POLICY REPORT
DEVELOPMENT AND BUILDING

TO: Vancouver City Council
FROM: General Manager of Planning and Development Services
SUBJECT: CD-1 Rezoning - 516 West 50th Avenue and 6629-6709 Cambie Street

Figure 2: Site Plan

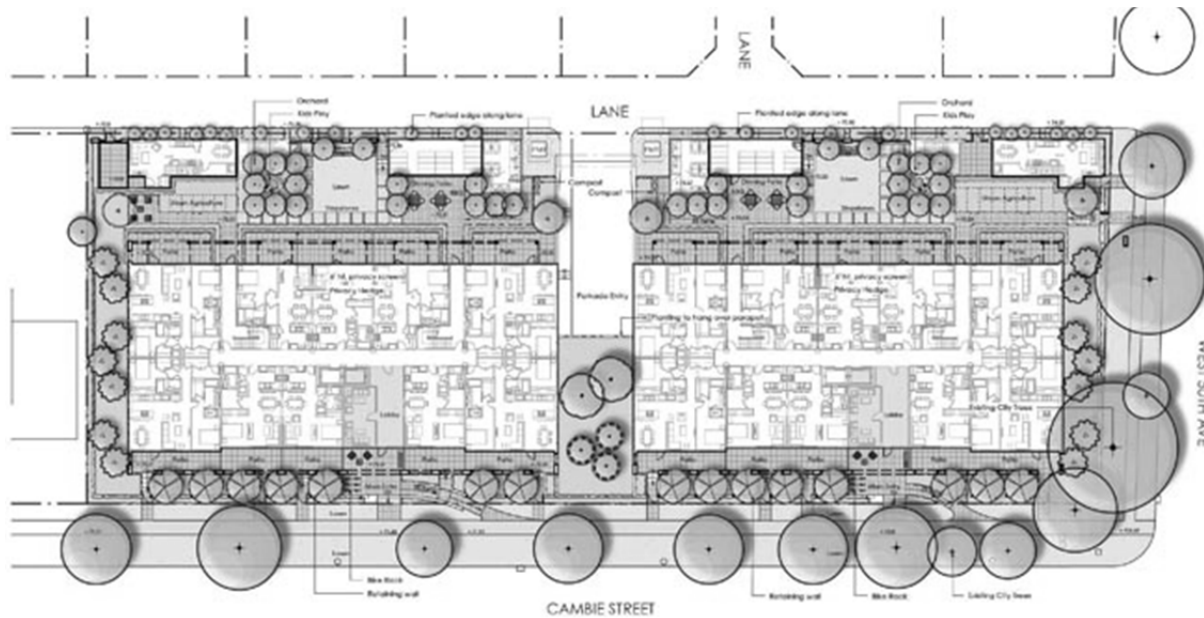
- 1. Elevation of the below-grade spaces proposed between 50th Avenue and the building.

Note to Applicant: Intent is to create more livable space and a better street interface by reducing the amount of outdoor space below the sidewalk and lane around the north end of the site, and to avoid the guard rails and retaining walls that would be required. Consider raising the main floor at the north end by two to three feet to improve this relationship. The building entry may be relocated northward to follow the rise in Cambie Street and minimize the length of ramps for disabled access.

- 2. Provision of a 1.2 m (4 ft.) rear yard for the majority of the lane to better accommodate landscaping, pathways, and a transition to the residential units.

Note to Applicant: Setback should be increased around building entries in particular to accommodate hand rails, steps, landings, and similar features; and to provide on-site access between the various amenities. The site design should consider pedestrian safety along this service lane. See also condition 4.

4. Provision of outdoor, on-grade access paths through the site to enable residents and visitors to enjoy better access between the proposed bicycle facilities, outdoor common spaces, townhouses, Cambie Street, and the lane.

Note to Applicant: This can be accomplished with a 1.2 m (4 ft.) wide path from east to west through the middle of this 108.5 m (356 ft.) wide site, and a similar path from north to south.

5. Design development to provide more openness between the two principal buildings.

Note to Applicant: Intent is to improve the real and perceived open area between buildings as intended in the *Cambie Corridor Plan*, and to improve livability and access to natural light for units facing into the aperture. This can be accomplished by continuing the shoulder line above the fourth storey around the building, by providing a similarly scaled step in plan, or some combination thereof.
